Minutes
Cascade Charter Township
Planning Commission
Monday, November 13, 2023
7:00 pm
2870 Jacksmith Ave SE

STAFF REPORT: Case # 22-3798
REPORT DATE: October 27, 2023
PREPARED FOR: Cascade Charter Township Planning Commission
MEETING DATE: November 13, 2023
PREPARED BY: Madison Smith-Jacoby

STAFF REPORT: Case # 23-3795
REPORT DATE: November 4, 2023
PREPARED FOR: Cascade Charter Township Planning Commission
MEETING DATE: December 4, 2023
PREPARED BY: Madison Smith-Jacoby, Zoning Administrator

STAFF REPORT: Case # 23-3800
REPORT DATE: November 17, 2023
PREPARED FOR: Cascade Charter Township Planning Commission
MEETING DATE: December 4, 2023
PREPARED BY: Madison Smith-Jacoby

**DIMENSIONAL PLAN FOR
PROPOSED CEMETERY GRAVE SITES**
PART OF THE NW 1/4 OF SEC. 33, T6N, R10W
CASCADE TOWNSHIP, KENT COUNTY, MICHIGAN

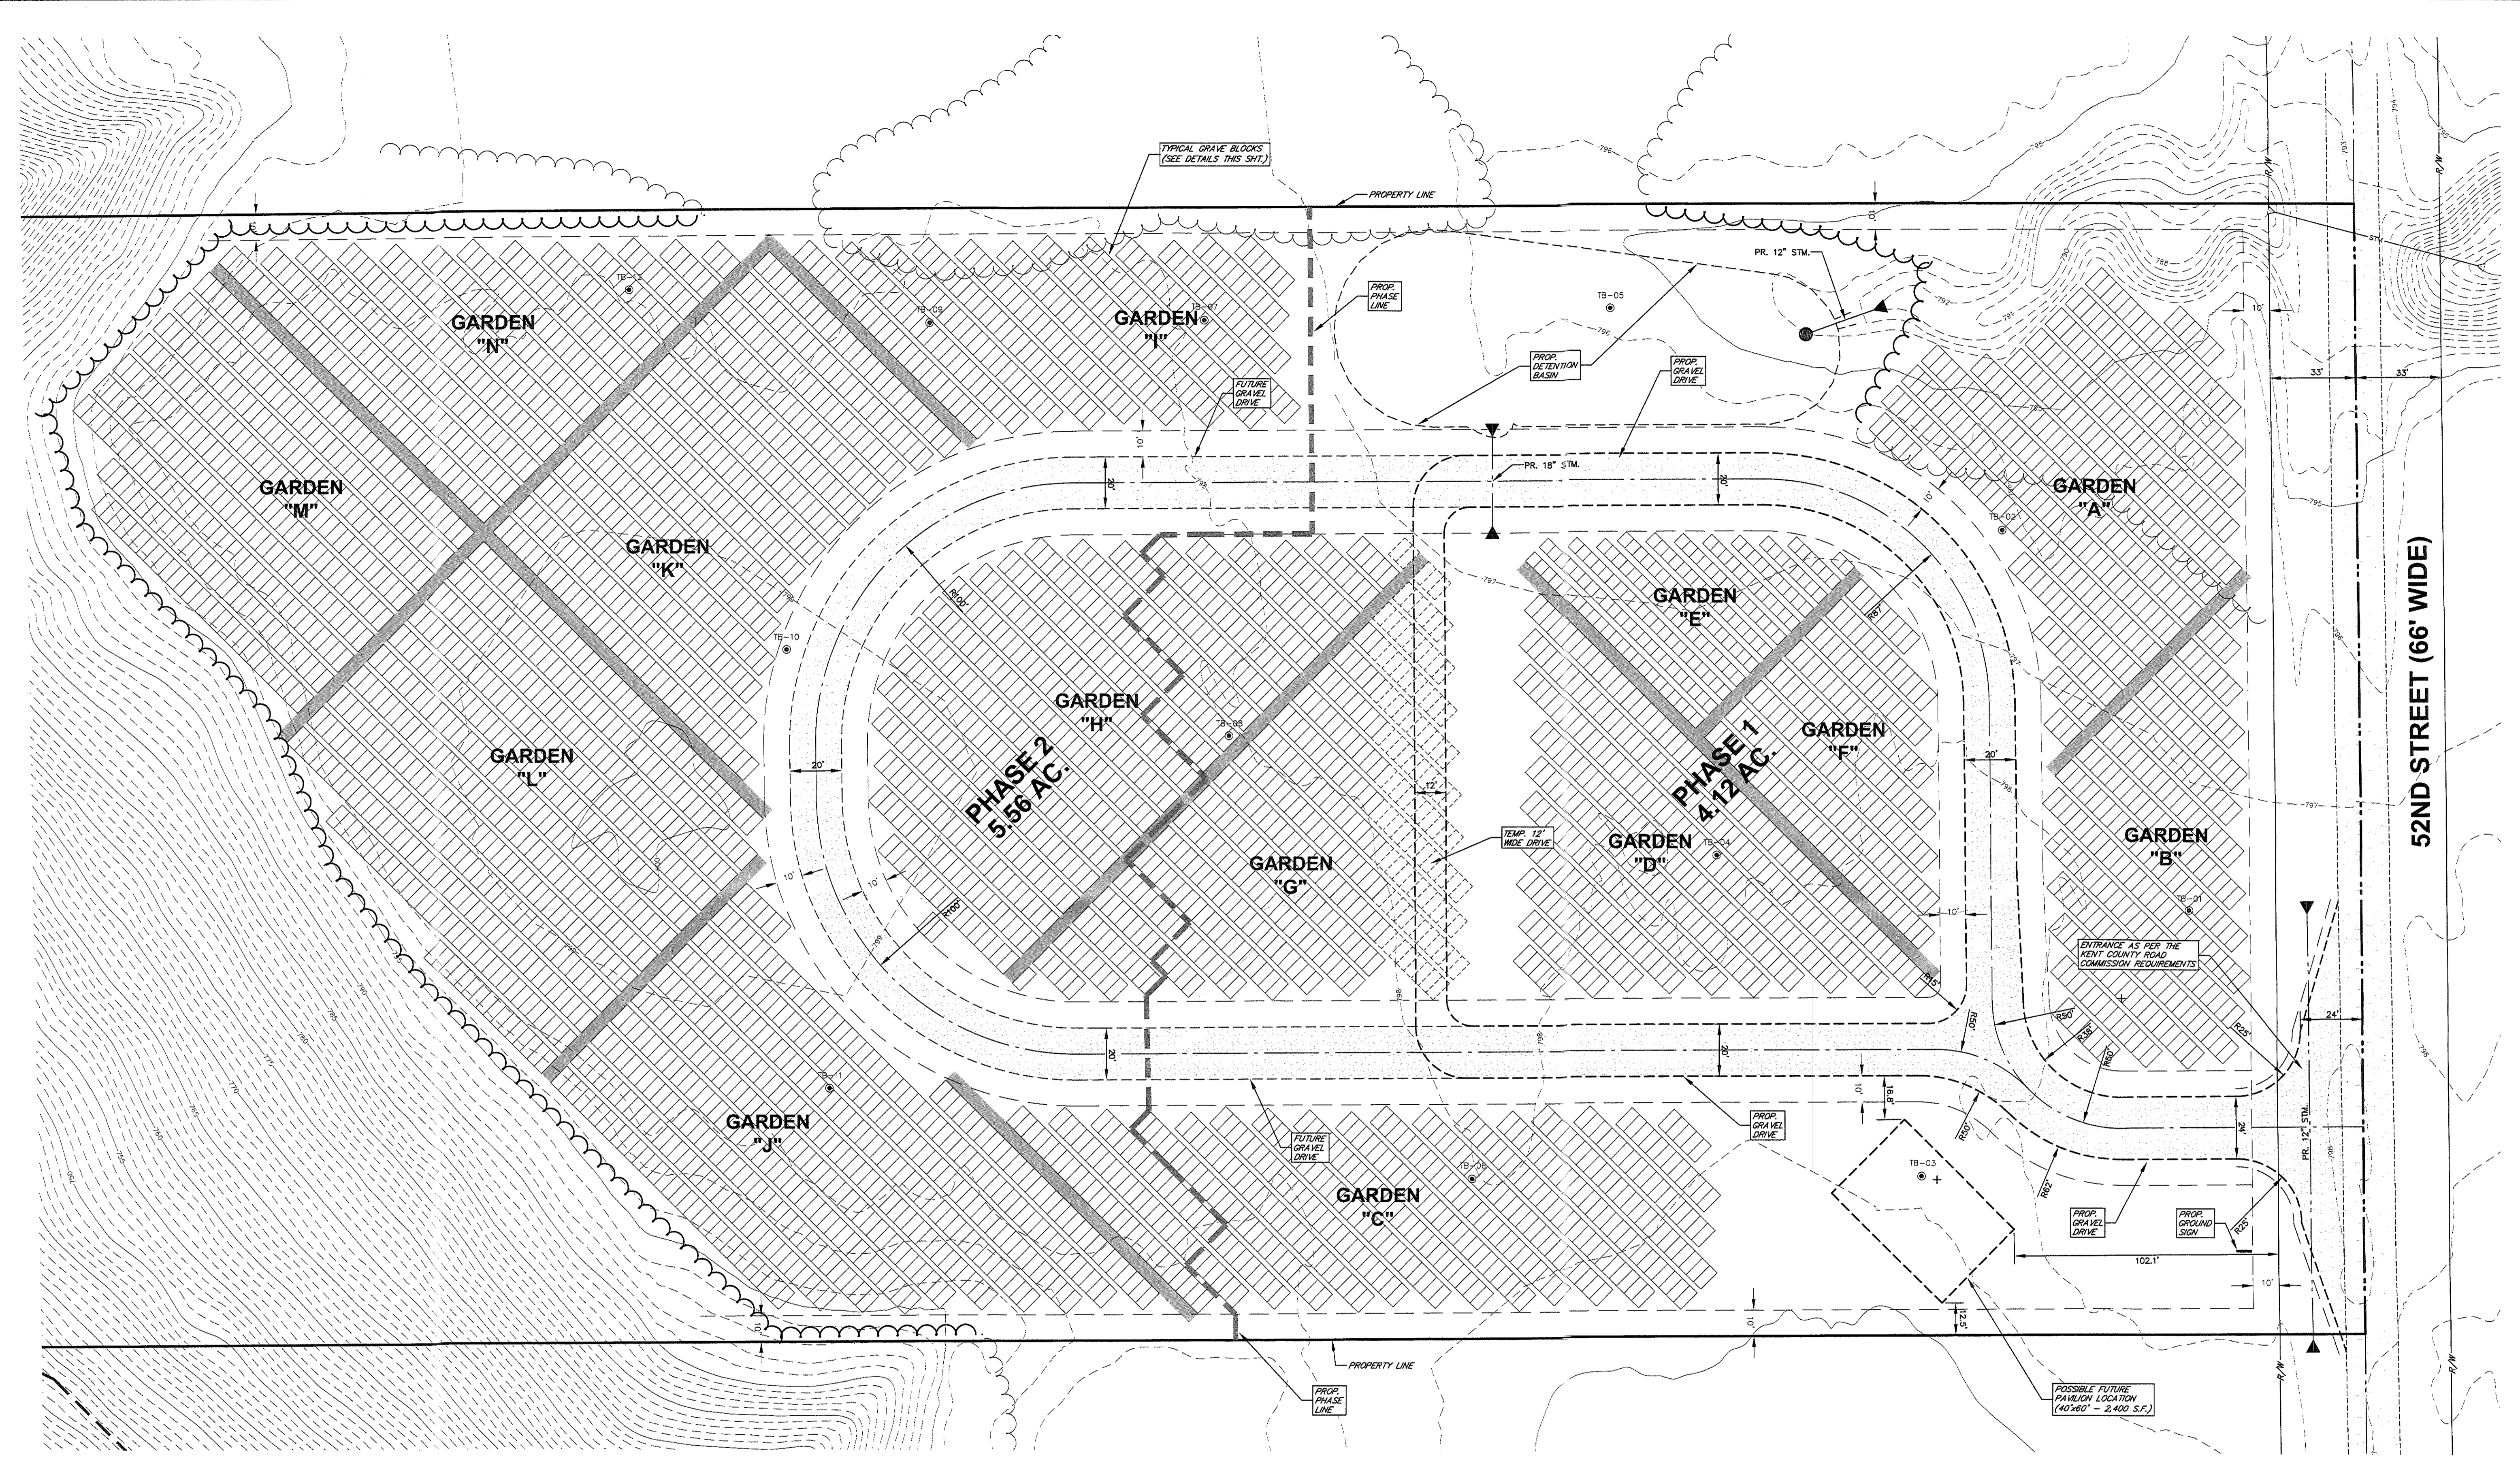
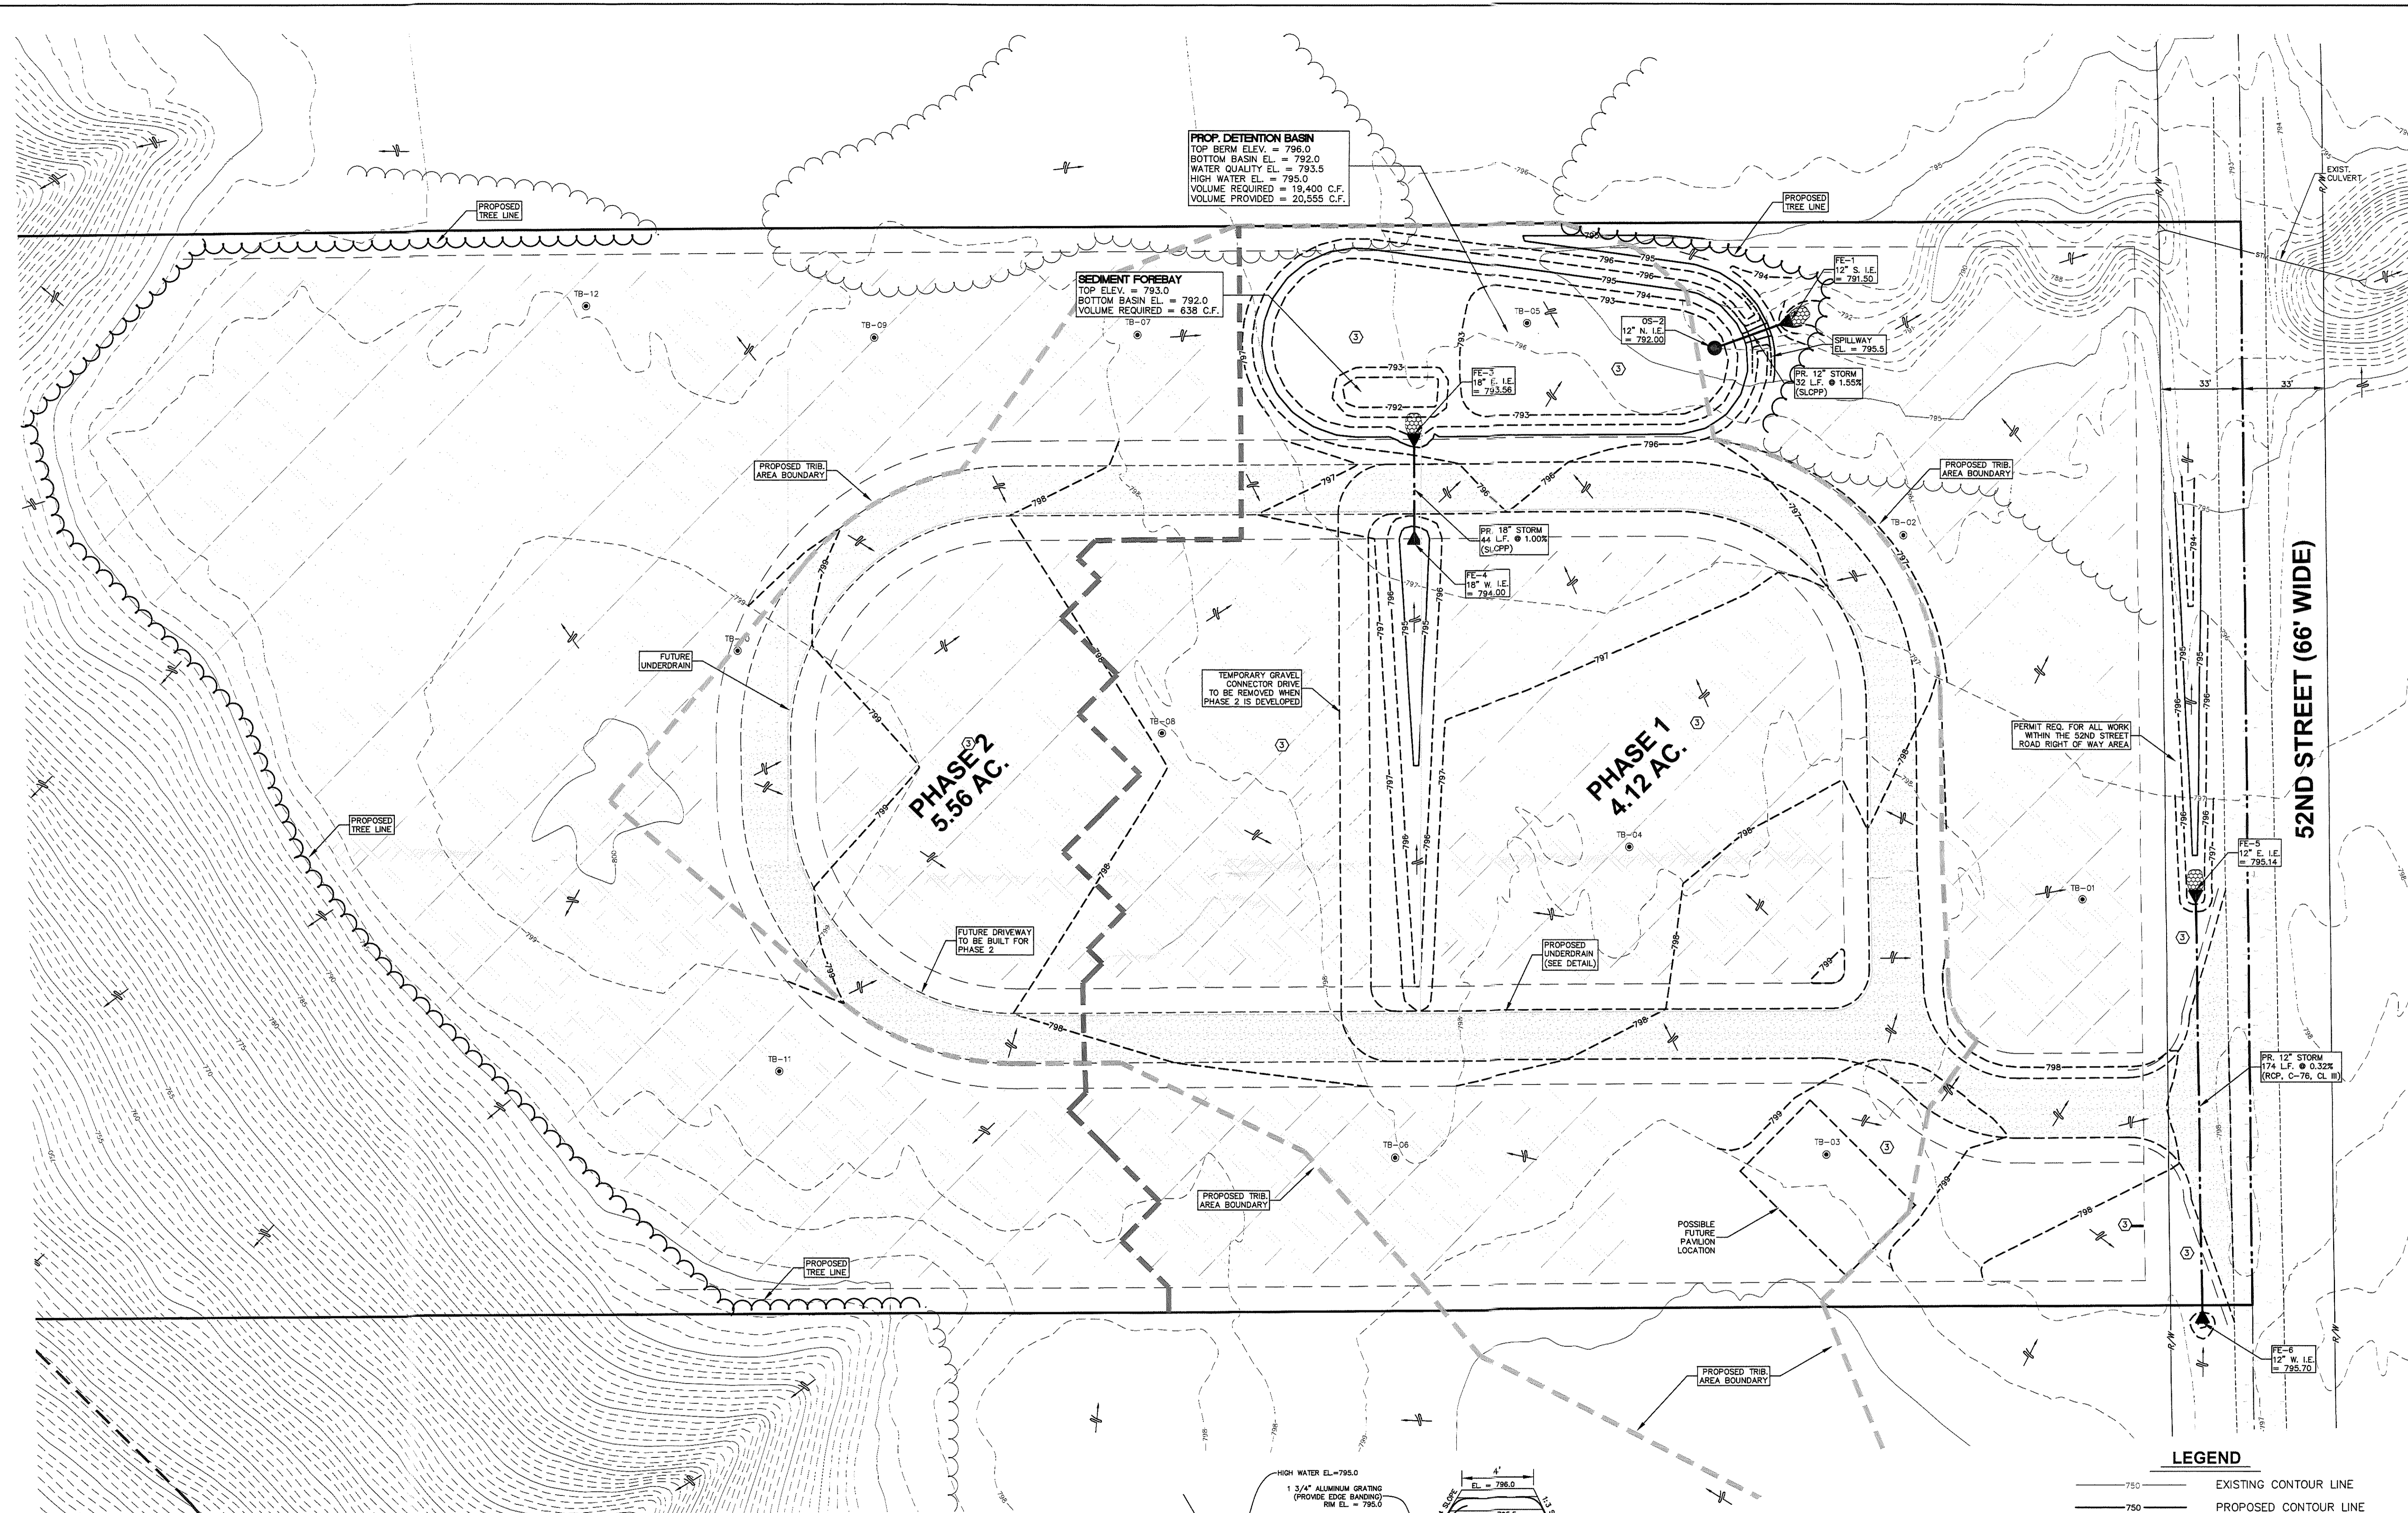
4. The site plan indicates that there would be no electric, water, or sewer on the property.
5. Because no utilities are proposed, a lighting plan has not been submitted. The Planning Commission may want to consider if lighting will be required for approval.

8. No new landscaping is proposed and only a 10-foot buffer is proposed at the side property lines. While no buffer yard is outlined as being required for this use in Chapter 17, the Planning Commission may want to consider landscaping requirements between parcels of different uses. Tree clearing is proposed and the board may request further details.

1. Stormwater Maintenance Agreement is submitted prior to any construction.
2. A long-term cemetery maintenance plan is submitted prior to any construction.
3. All state and county requirements are met and necessary permits obtained prior to construction.
